SIGNED EXPLANATION OF SIGNIFICANT DIFFERENCES TO THE RECORD OF DECISION FOR SOLID WASTE MANAGEMENT UNITS 1, 211-A, 211-B, AND PART OF 102 VOLATILE ORGANIC COMPOUND SOURCES FOR THE SOUTHWEST GROUNDWATER PLUME AT THE PADUCAH GASEOUS DIFFUSION PLANT, PADUCAH, KENTUCKY, DOE/LX/07-2480&D2

**Explanation of Significant Differences to the
Record of Decision for Solid Waste Management Units 1,
211-A, 211-B, and Part of 102 Volatile Organic Compound
Sources for the Southwest Groundwater Plume
at the Paducah Gaseous Diffusion Plant,
Paducah, Kentucky**

Date Issued—November 2022

Figure 4. SWMU 211-A Monitoring Well Layout

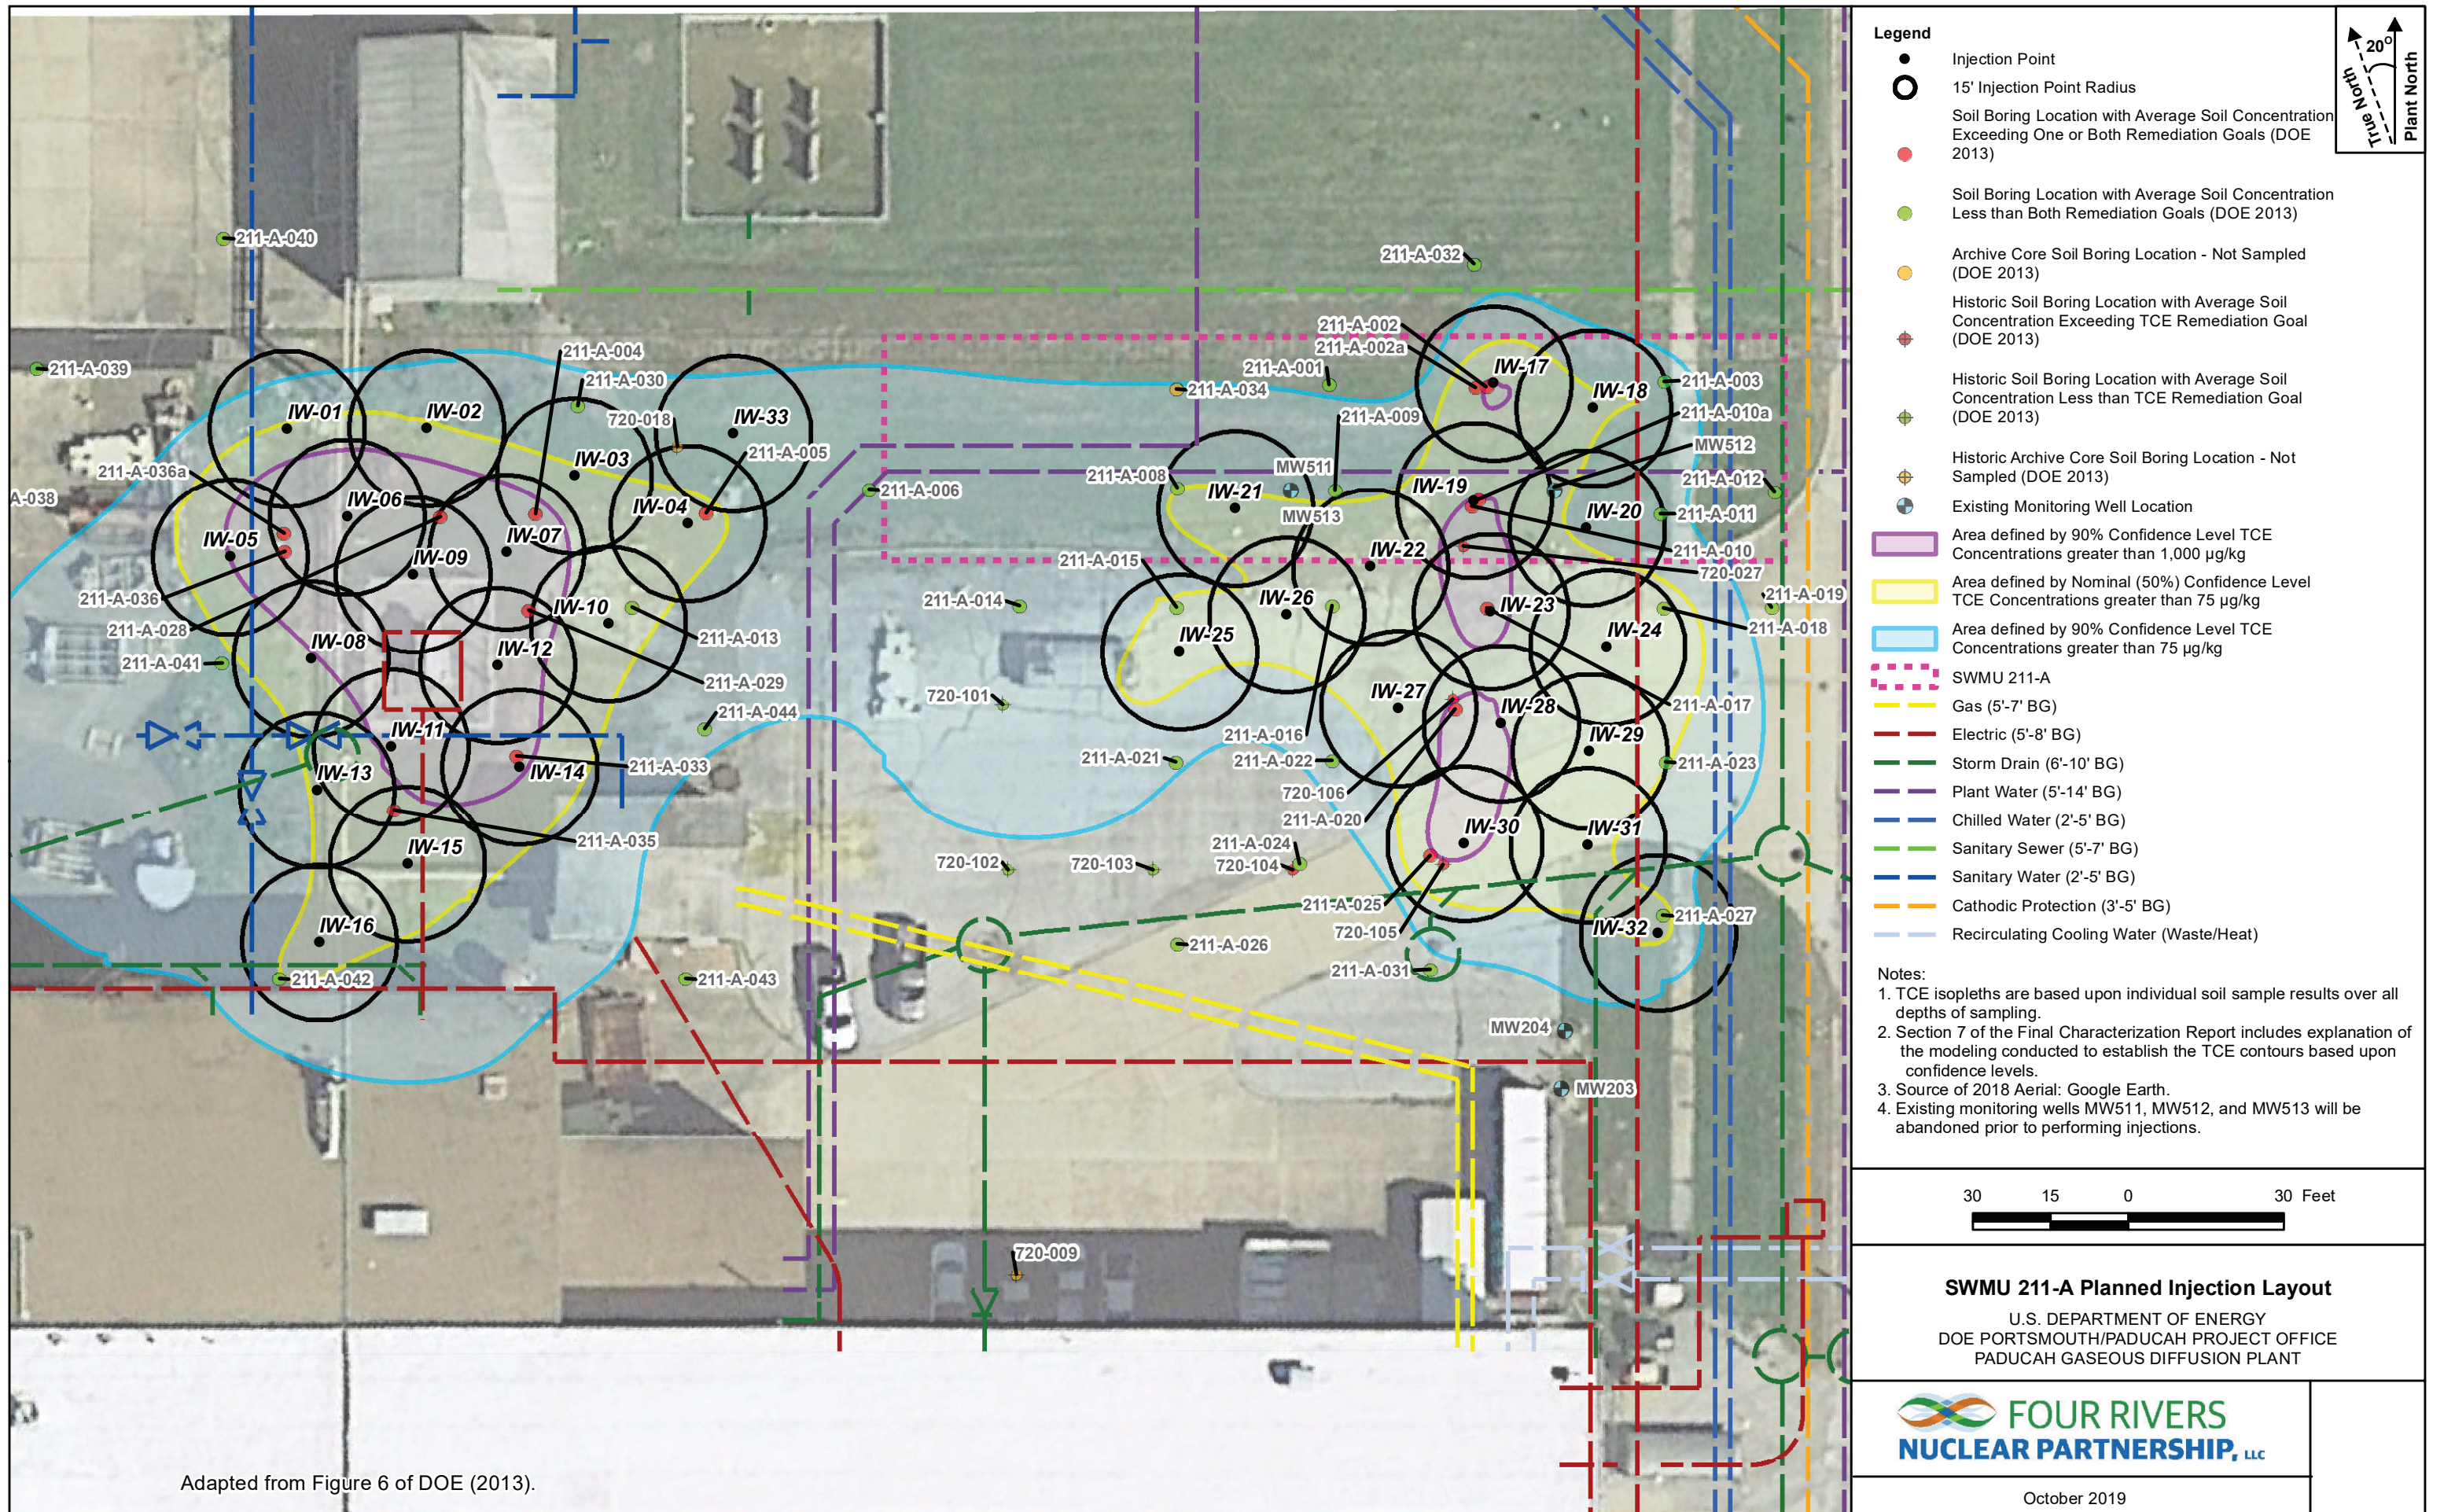
The SWMU 211-A monitoring well layout is shown on Figure 4. The procured remedial action cost to support the increase is approximately \$10M, as compared to the ROD’s estimated cost of \$3.7M. While the cost increase is a significant change, it does not alter or fundamentally change the remedy selected in the ROD.

Figure 3. SWMU 211-A Planned Injection Layout

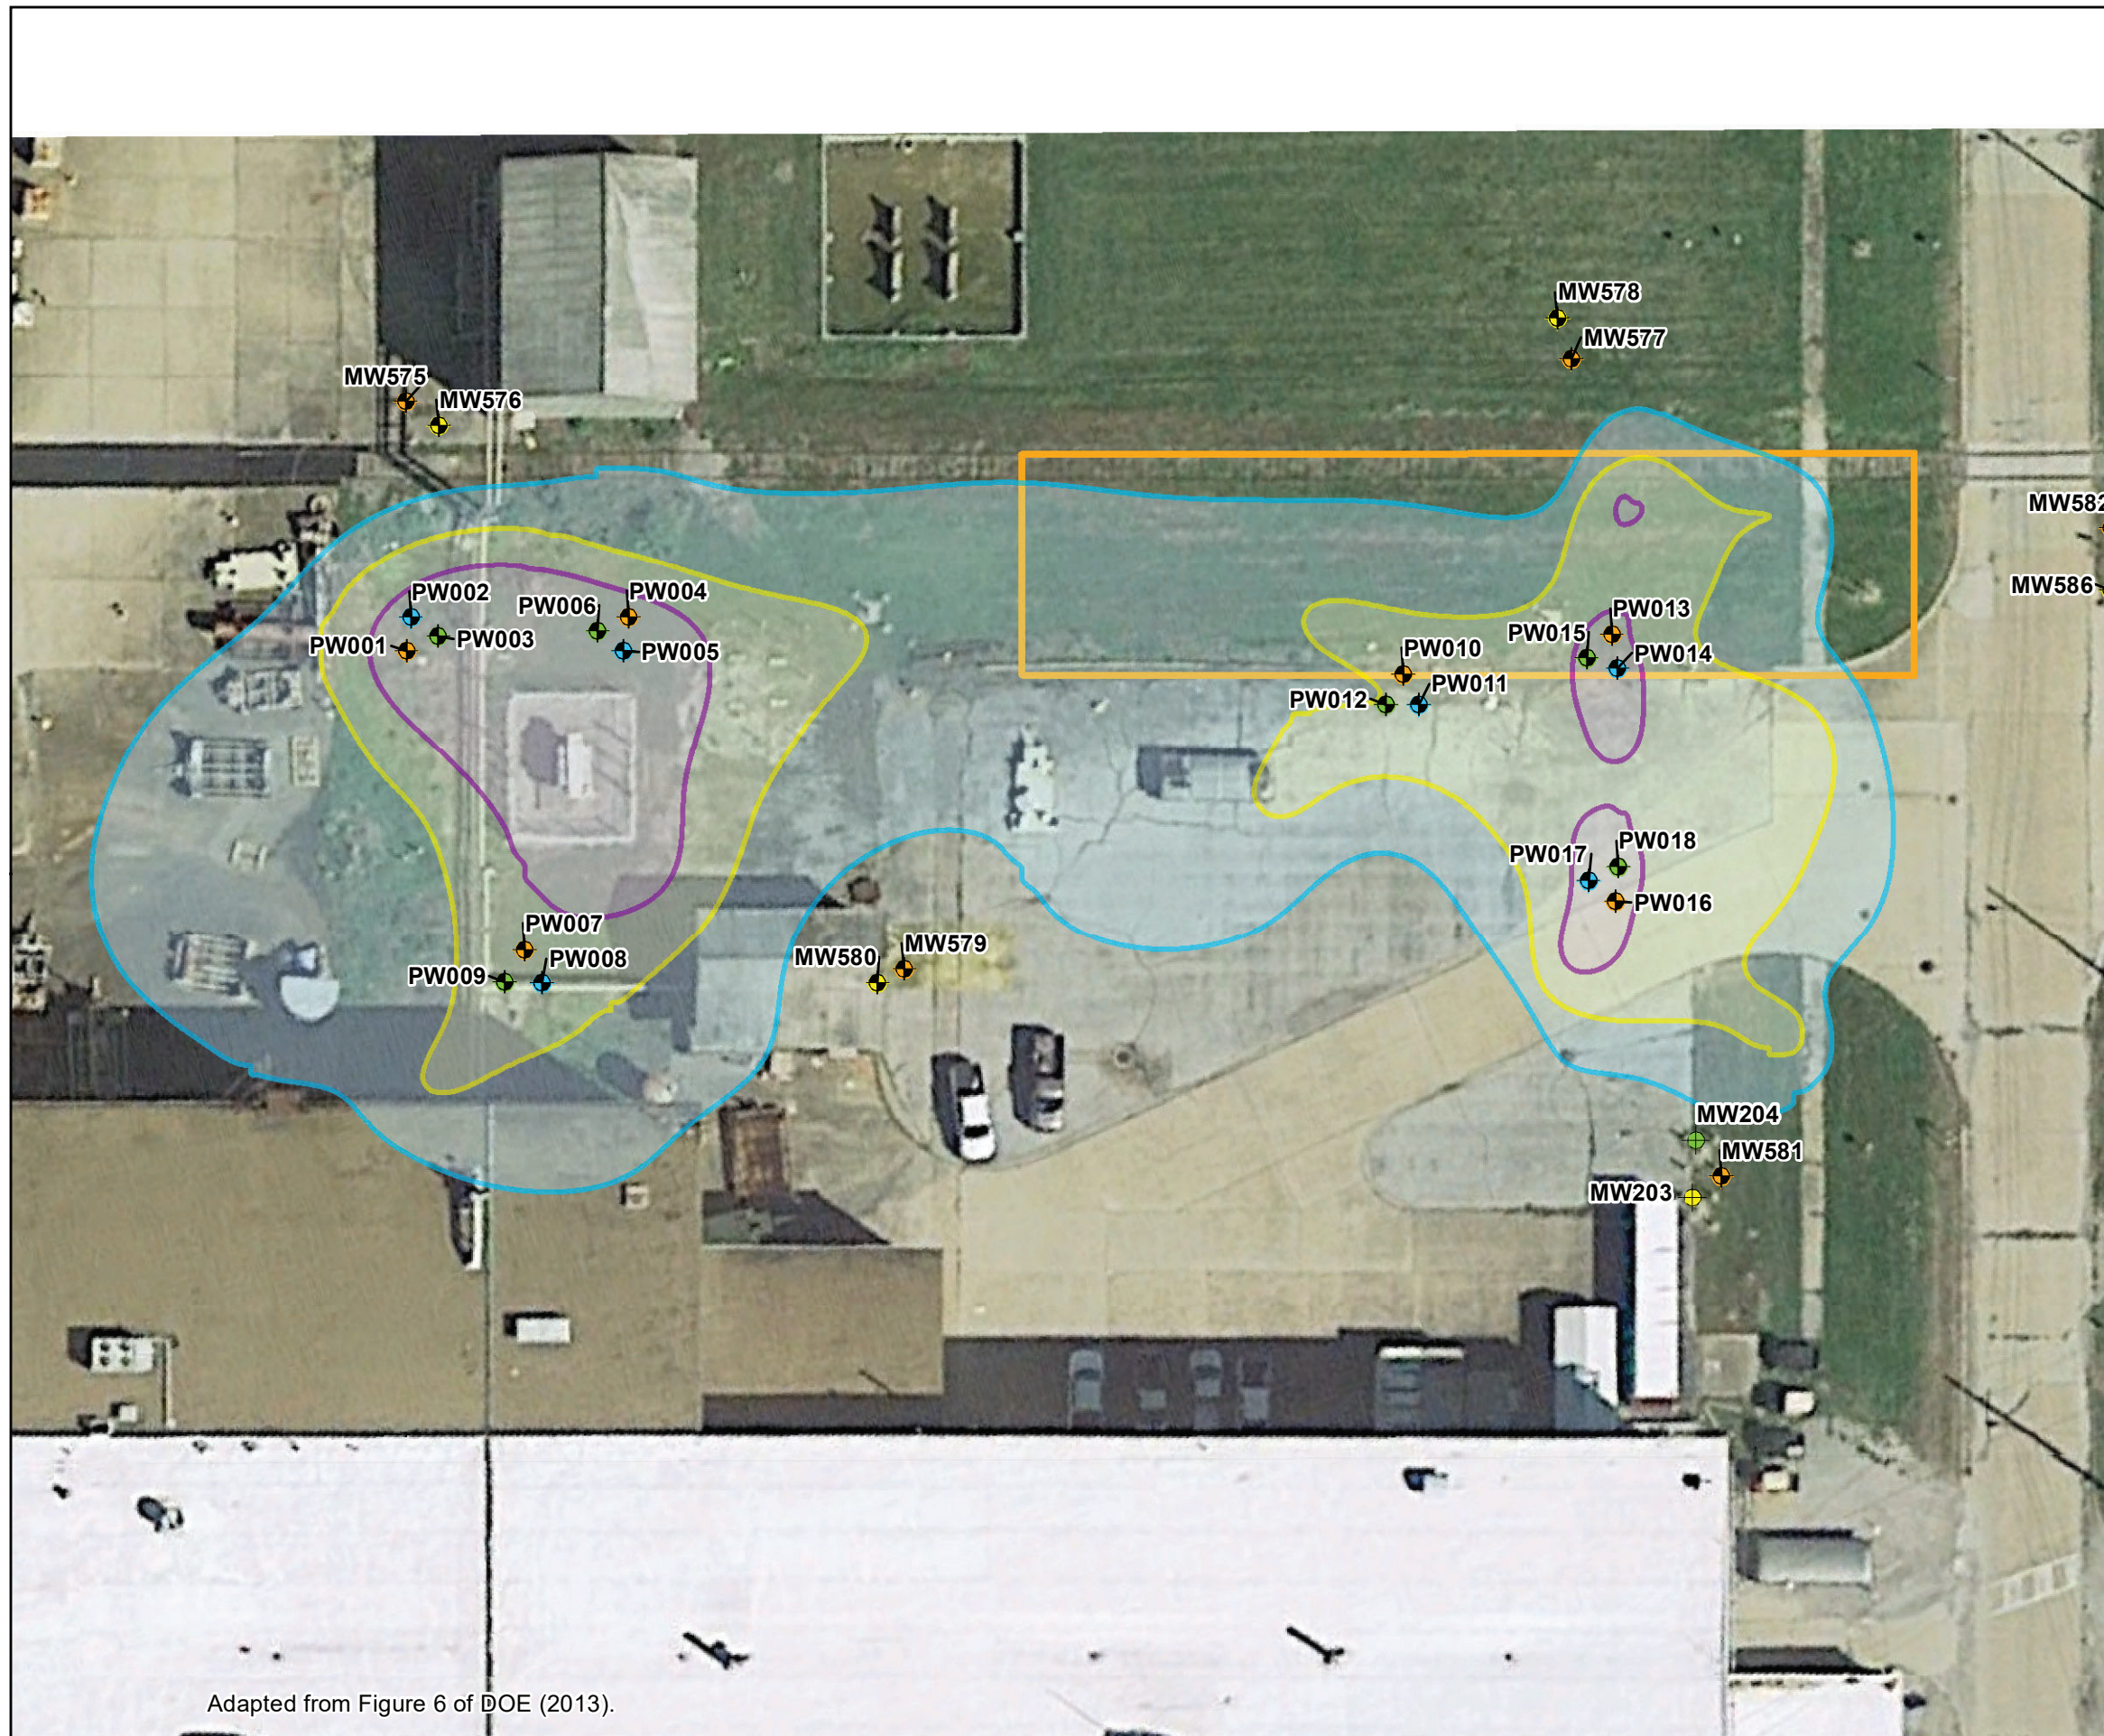
- Injection wells—33 locations (85 wells) from 6 locations (18 wells) in the ROD;
- MW network—9 wells external to the treatment area from 4 wells in the ROD; and
- Performance MW network—18 wells internal to the treatment area from 0 wells in the ROD.
